In the Drawings

The attached replacement and annotated sheet(s) of drawings include changes to FIG. 1 and FIG. 2 as follows:

ROBERT E. KREBS, THELEN REID & PRIEST LLP
 Serial No.: 09/885,811
 Filed: June 19, 2001
 TRP DOCKET NO.: 034942-245
 Annotated Sheet Showing Changes

Fig. 1

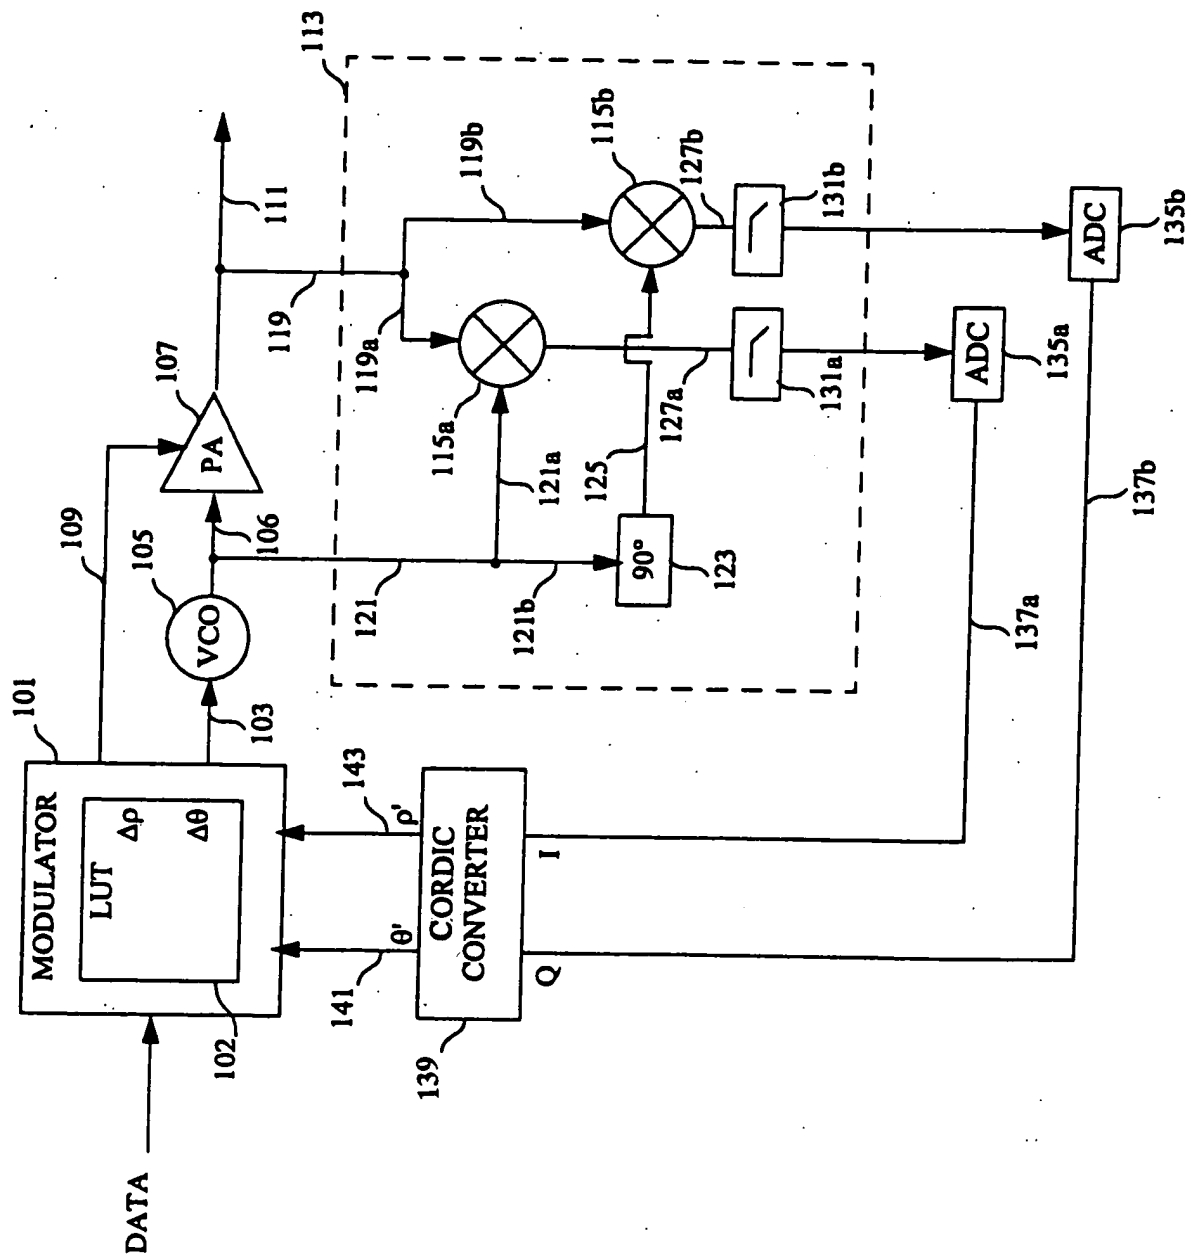
FIG. 1 has been amended such that box 121 has been relabeled 139 for consistency with the specification, and the descriptive legend has been changed from “chordic converter” to “cordic converter” to thereby correct the misspelling.

Fig. 2

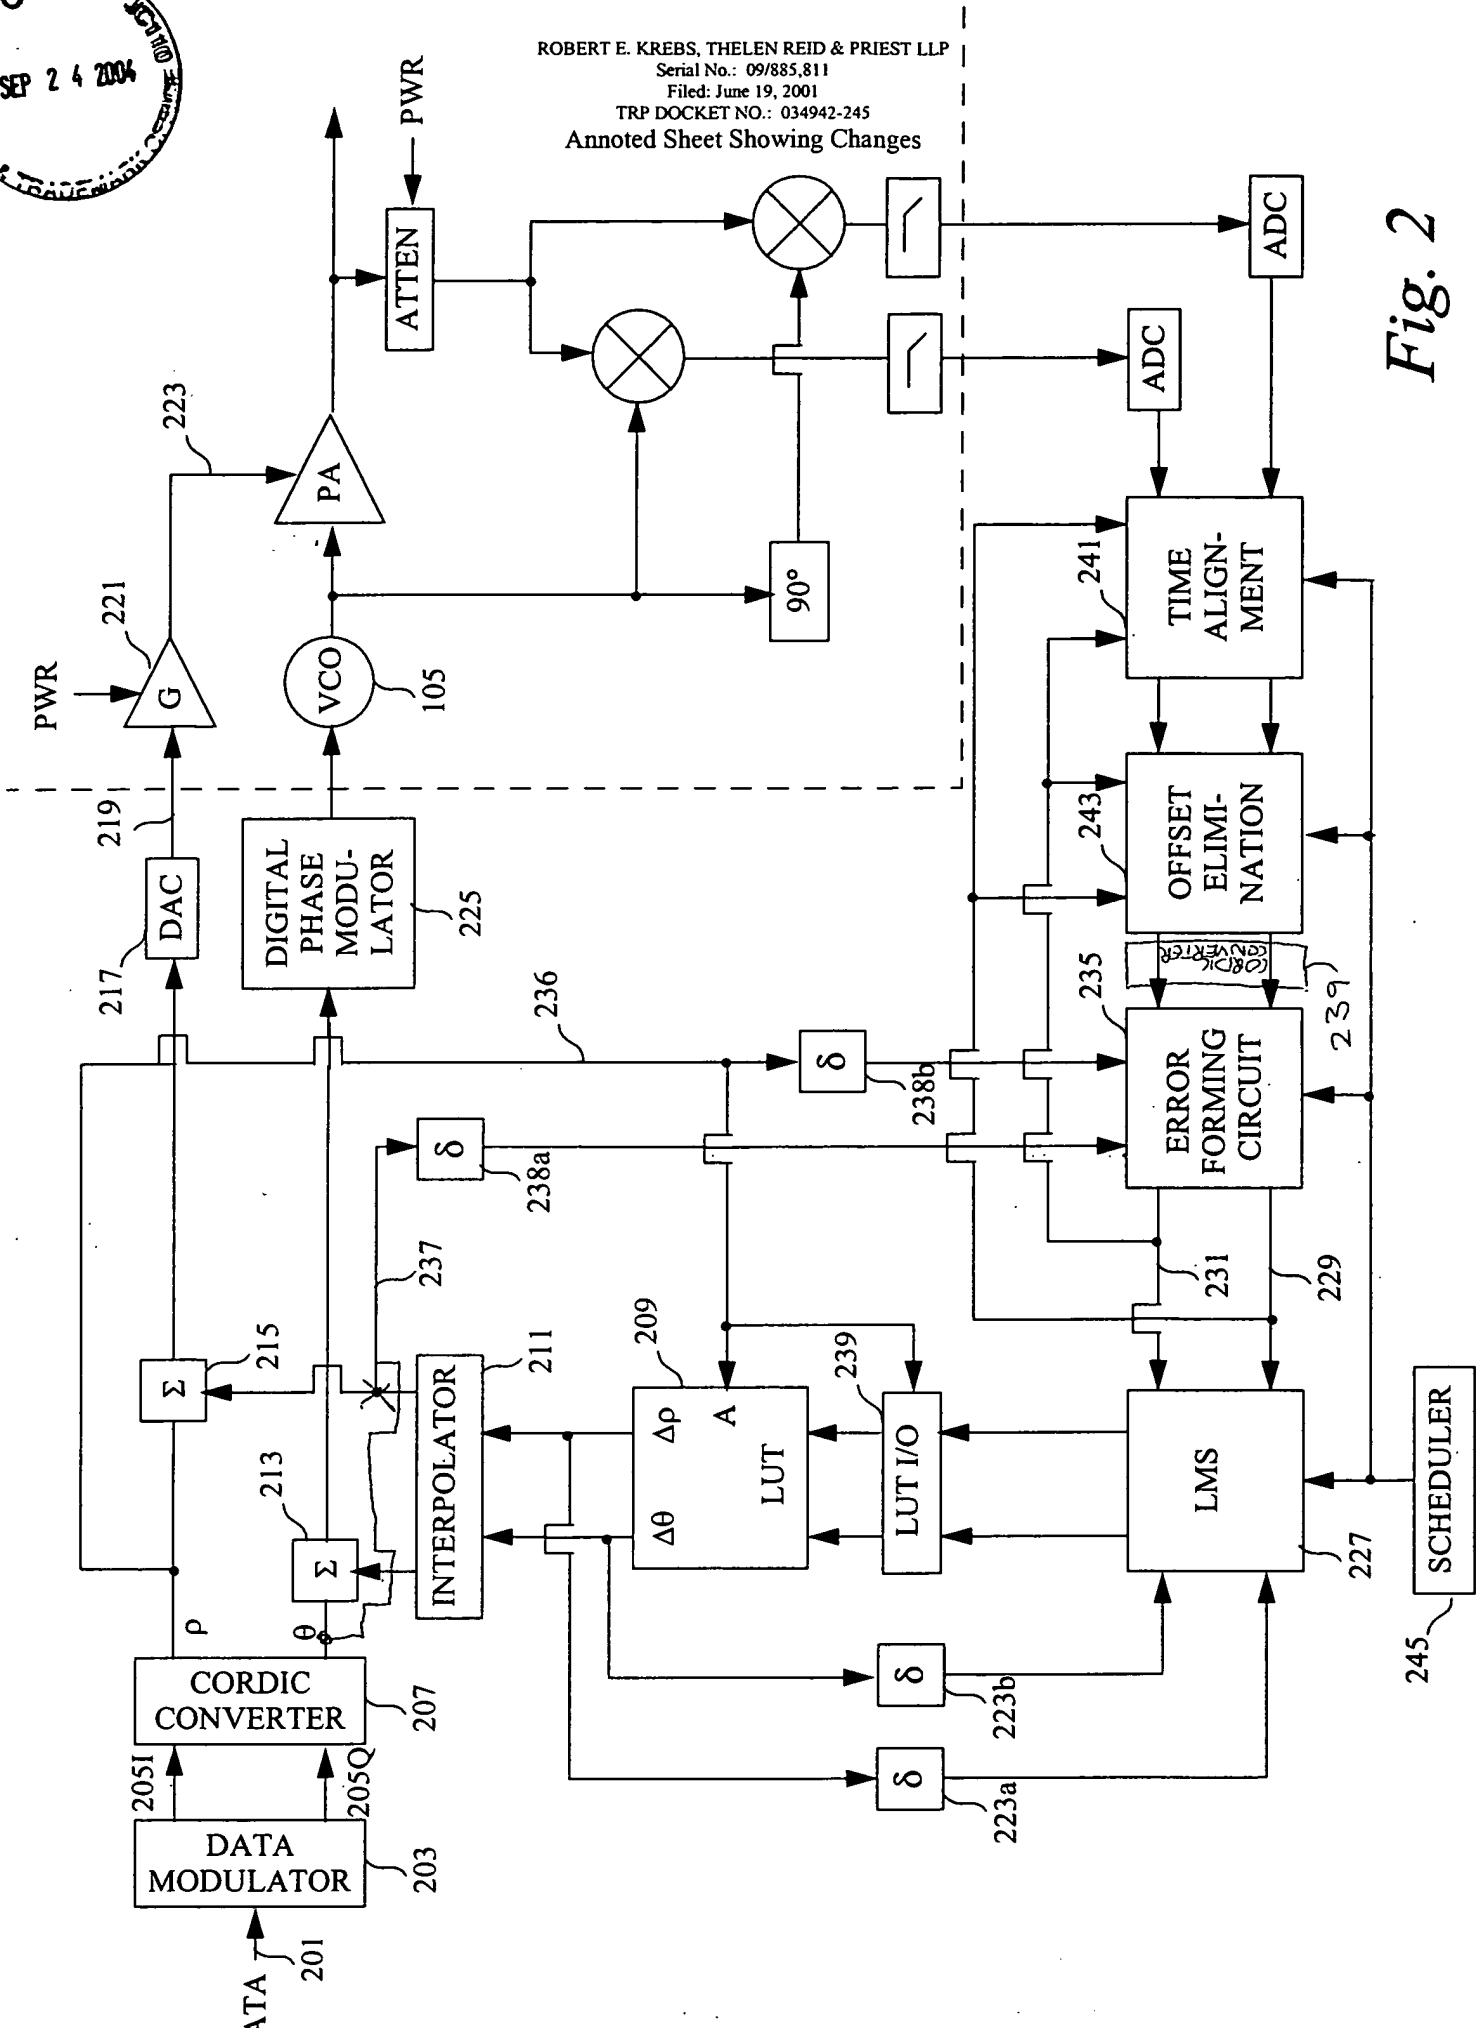
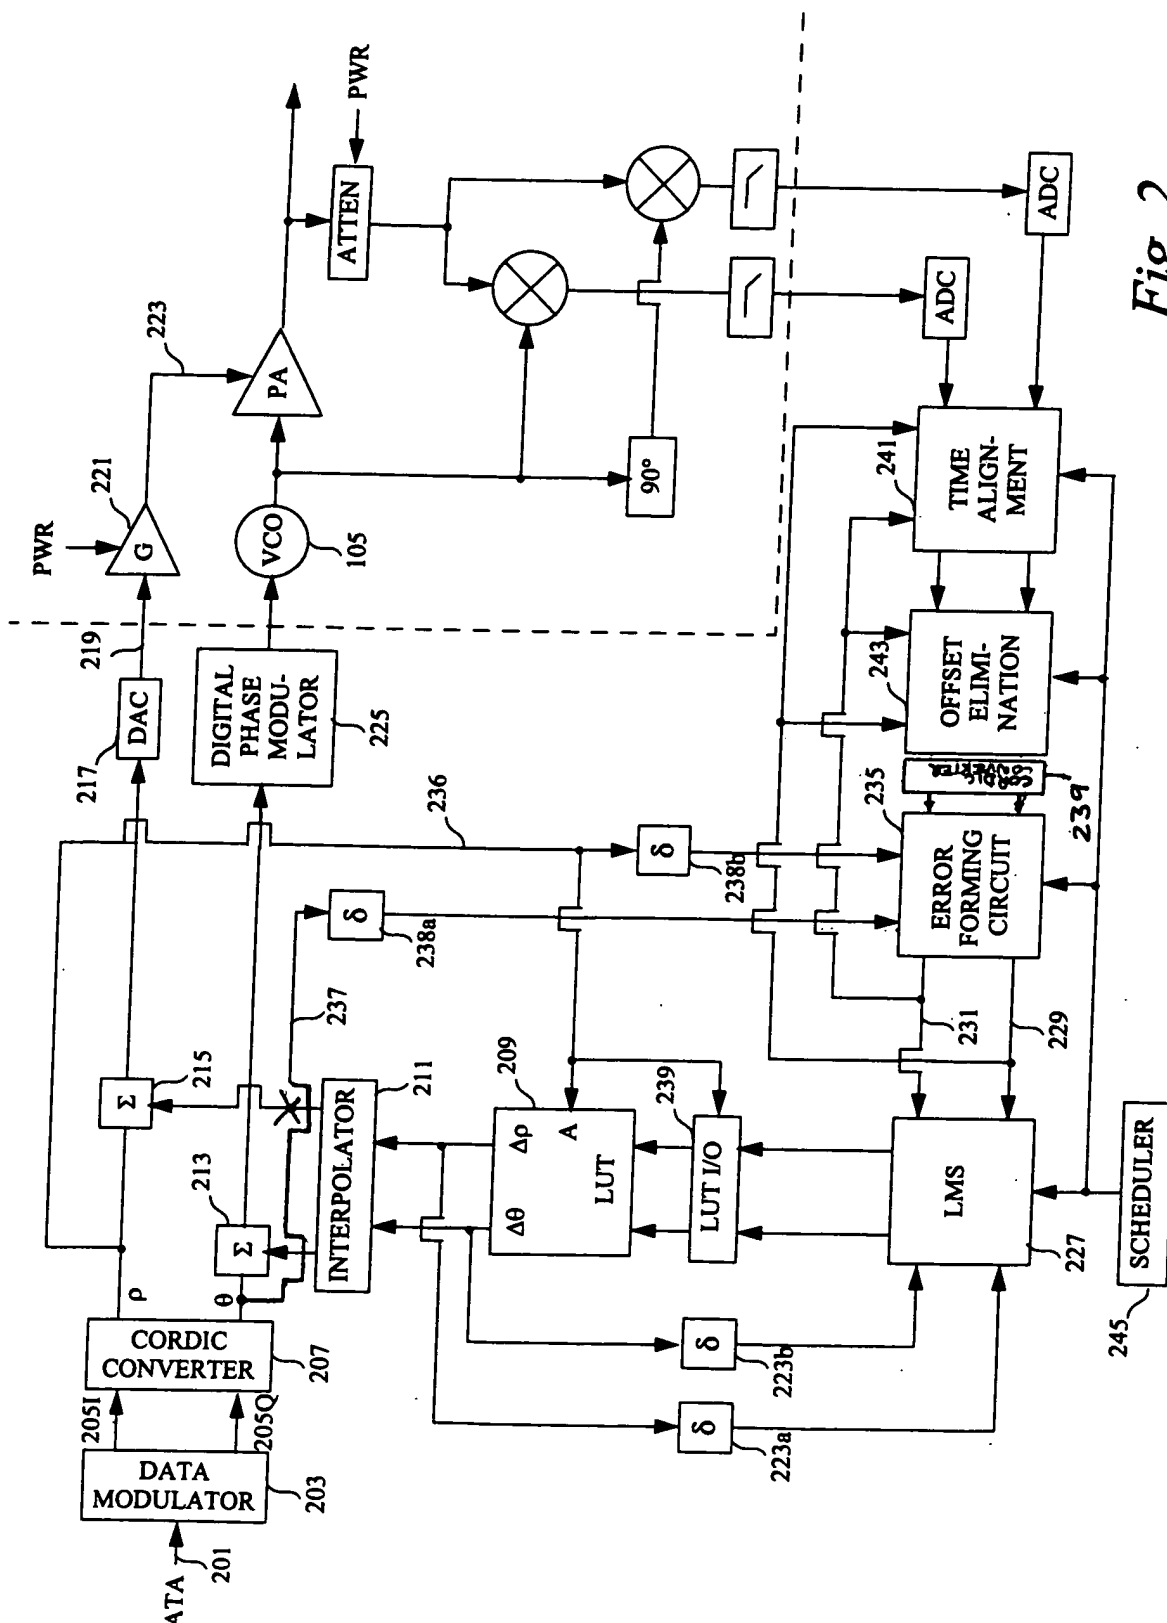
FIG. 2 has been amended to re-route the connection 237 to the delay element 238, and to insert cordic converter 139 of FIG. 1 in its proper place for consistency with FIG. 1 and the remainder of the description.
